# Service Bulletin N° 91

**SUBJ:** *TWISTER* Magnet Processor Board & Magnet Disc Motor Updates

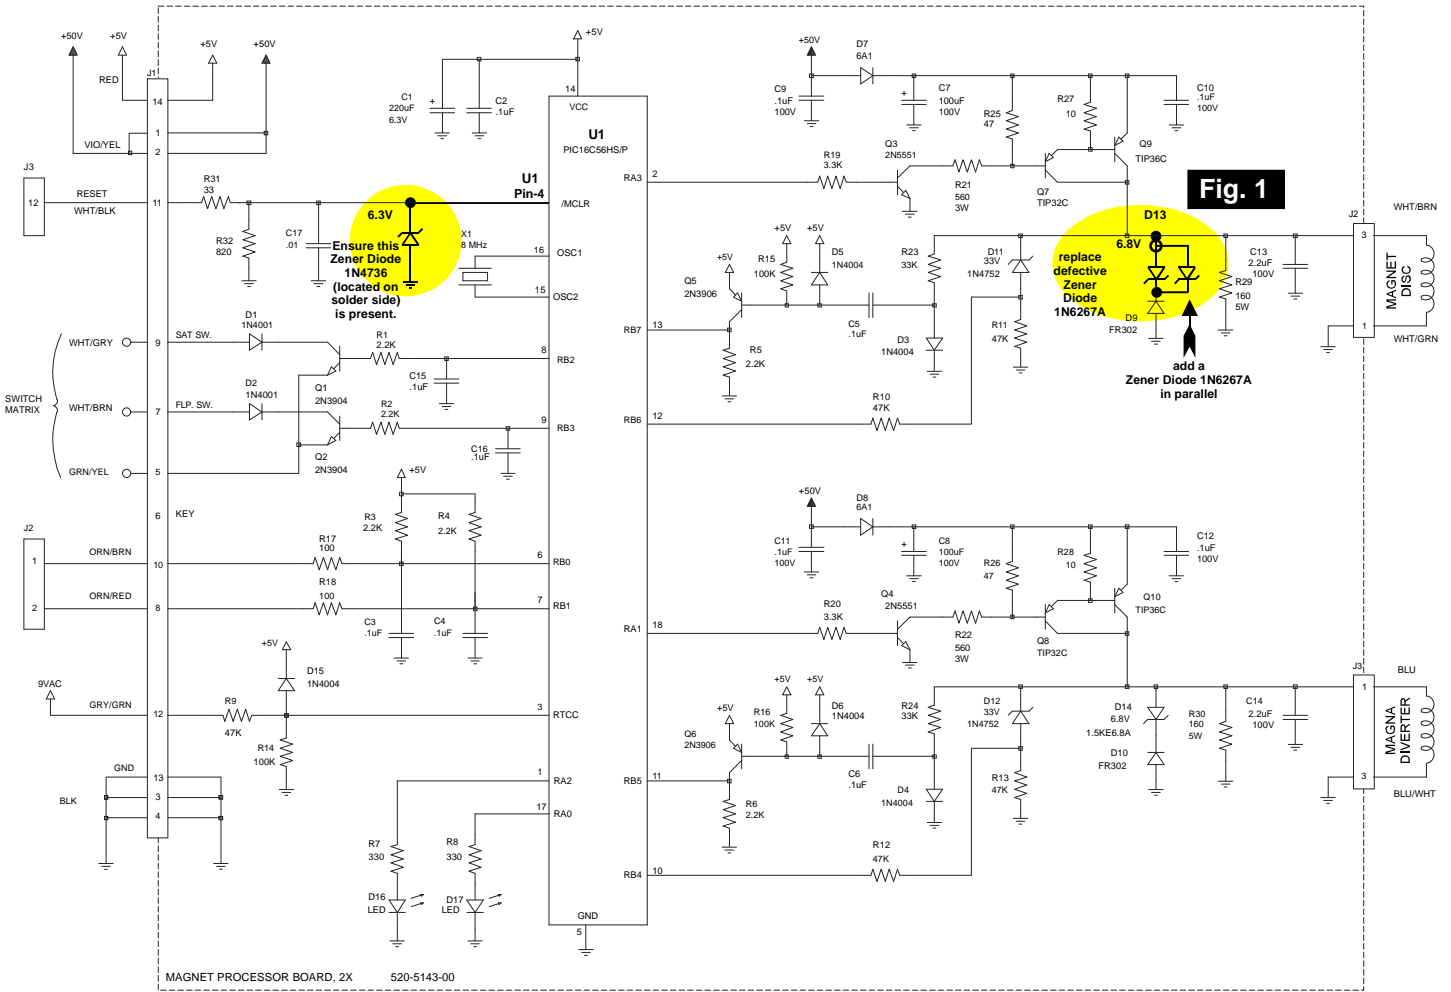
The Skill Shot is awarded when the Right or Left Flipper Button is pressed at the start of each ball while the ball is still in the shooter lane, the Spinning Disc Magnet intermittently energizes throughout the course of a game and the 3 Amp Magnet Fuse located underneath the playfield may blow every couple of days.

This game extensively utilizes the Magnet Feature during Multiball ("sense & grab" and "holding of the pinball"). The Zener Diode 1N6267A, Loc. D13, may have failed and is now *shorted* (check with a meter). A contributing factor to this diode failure is an intermittent reset problem which may be contributed by noise from the Neon Bulb across the Spinning Disc Motor Connector.

Replace the defective Zener Diode 1N6267A, Sega Part N° 112-5011-00, and add one in parallel at Loc. D13; Ref. Fig. 1 on the Magnet Processor / Driver Schematic *on the next page*.

# MAGNET PROCESSOR SCHEMATIC

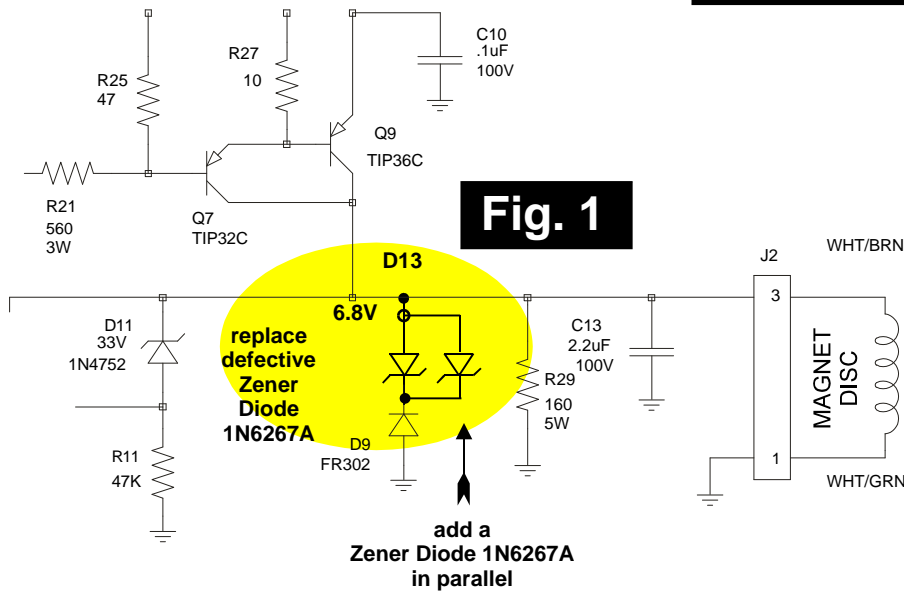
**Please Note: Update your Manual Schematic, Section 5, Chapter 2, Page 90: As shown above, J2 should be Magnet Disc, and J3 should be Magnet Diverter. The manual referenced them the other way around.**

**Twister Mag Update Kit, Part # 500-6173-00 includes two (2) each 1N6267A Diodes and one (1) each 22Ω 1/2 watt resistor.**

# MAGNET DISC MOTOR DRAWING

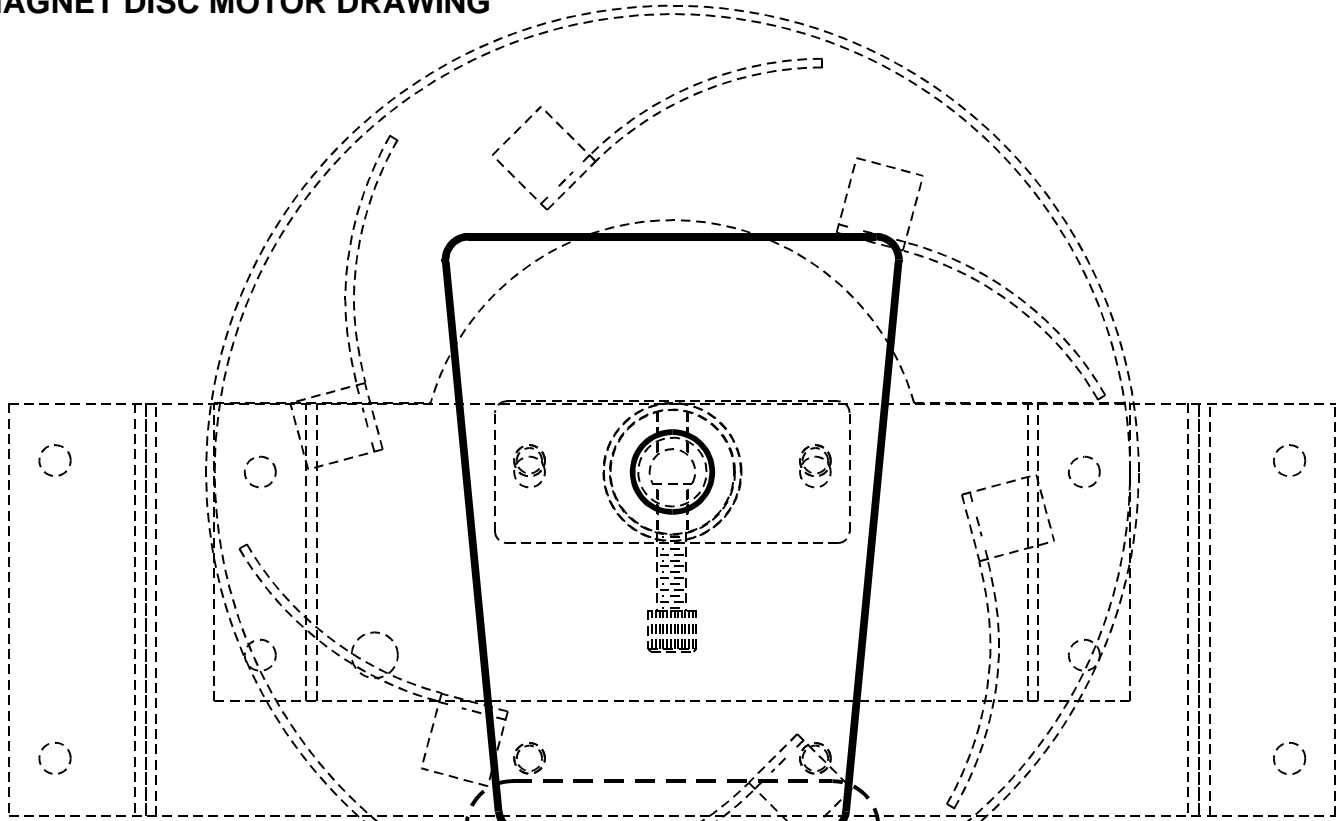
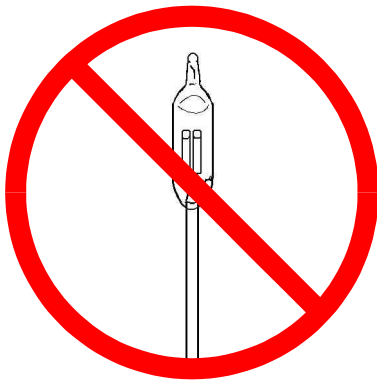
Remove the Neon Bulb  
from the Magnet Disc Motor  
Connector by clipping the leads.

This connector should have  
this large yellow capacitor, not the  
small "disc" shape .01 Capacitor.

22Ω 1/2W  
Resistor

After removal of the Neon Bulb, add  
this resistor in series with the Capacitor.
